Director's Report

Project Name: Trailside Meadow
 Description: Final Site Plan Amendment
 Date on Agenda this packet pertains to: August 19th, 2021

RE: Trailside Meadow- Phases 2 and 3 - Revised FSP Review #3

Subject: Trailside Meadow Planned Development
Final Site Plan Review #2 (amendment)

M/I HOMES OF MICHIGAN, LLC
TRAILSIDE MEADOW
FINAL SITE ENGINEERING PLAN
PHASES 2-3
LANDSCAPE PLAN - OVERALL

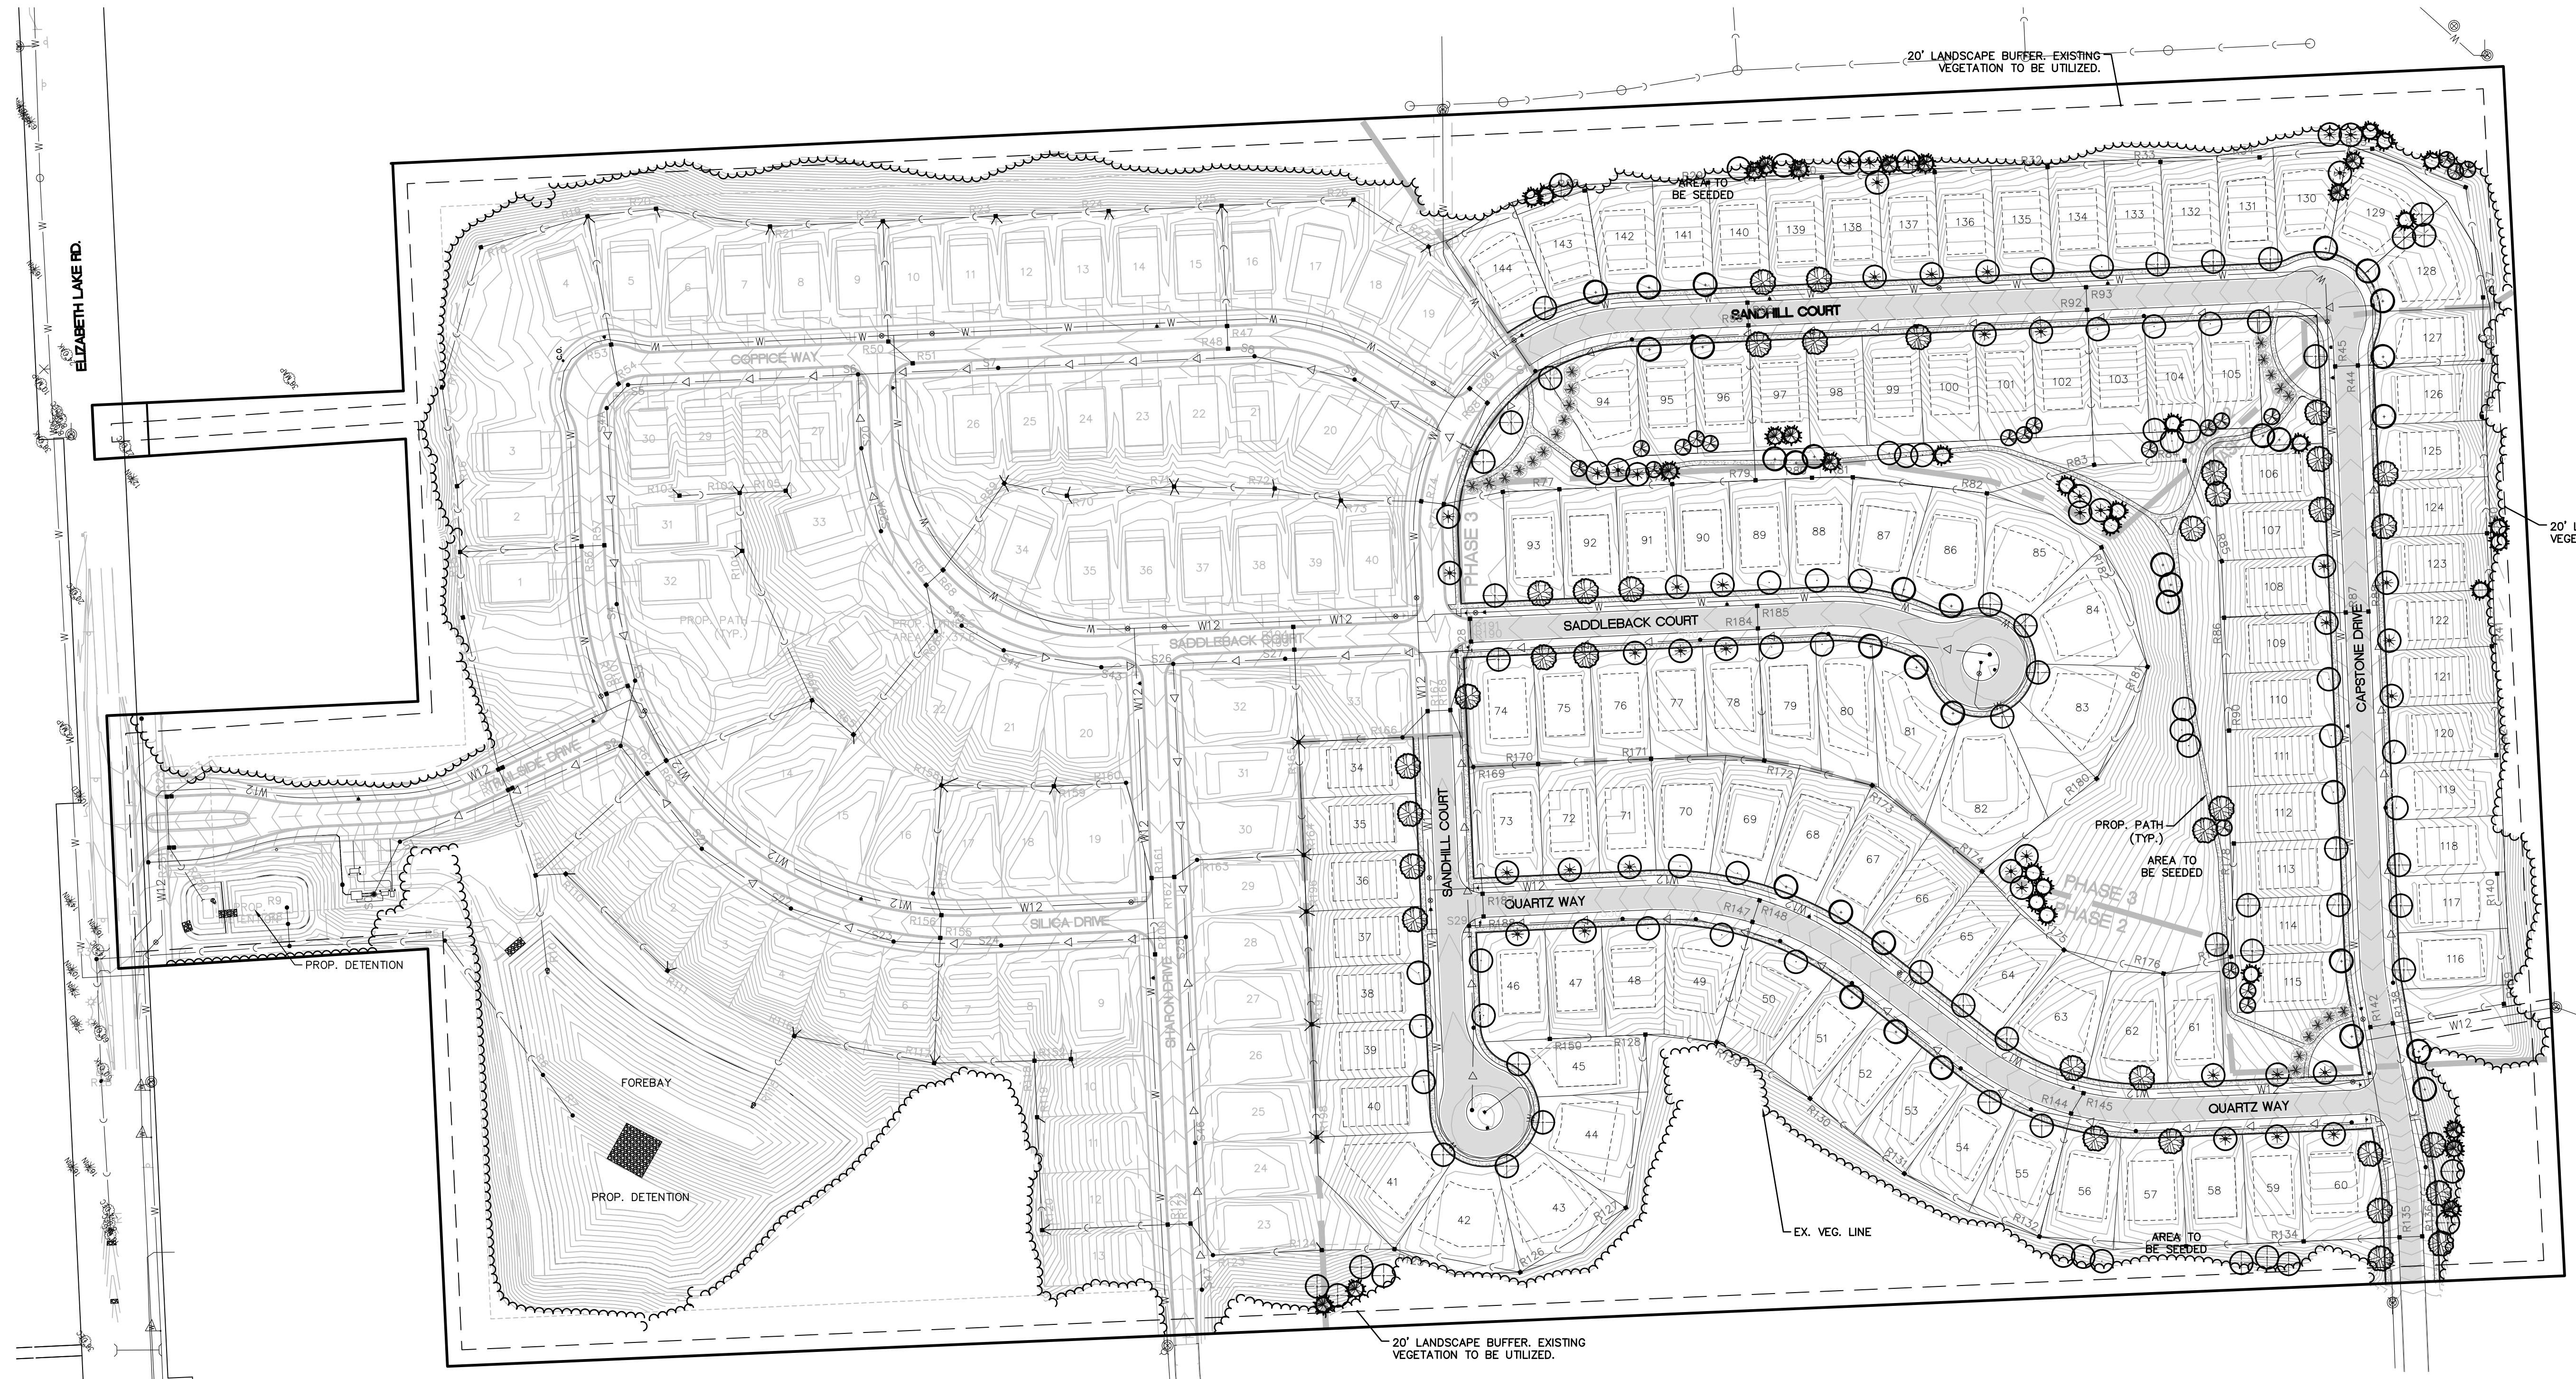
4. **Landscaping and Screening:** A landscape plan has been provided, which meets the landscape requirements in Section 5.19. However, the petitioner has reduced some of the plant material on the landscape plan (Sheet LS1) as follows:

- A change from one hundred thirteen 2-inch caliper Redbud (ornamental) trees to one hundred eight 2-inch caliper Flowering Crabapples;
- A change from six hundred eighty 36-inch high Viburnum to 642 Viburnum (same size)
- A reduction from one hundred two, 36-inch Sweetspire to ninety Sweetspire (same size)

Additionally, in the originally approved plan, the petitioner was utilizing the foundation plantings to meet the landscape requirements. This note is still on the revised plans, although a reduction of fifty-one active adult units indicates that the foundation plantings for those units have been eliminated or moved.

The petitioner should explain why there has been a reduction in landscaping plants and address the foundation plantings previously used to meet the landscaping requirements.

- 1. Plans submitted verifying a minimum of 65' of lot width along the right-of-way for lots on curvilinear streets or cul-de-sacs.
- 2. Petitioner addressing the decrease in amount of plant materials and whether or not the previously approved foundation plantings for the active adult units have been relocated or eliminated.
- 3. Outdoor lighting information provided, which meets the Zoning Ordinance requirements.
- 4. Petitioner providing lot width dimensions for lots, to ensure that they meet the minimum lot width requirements.
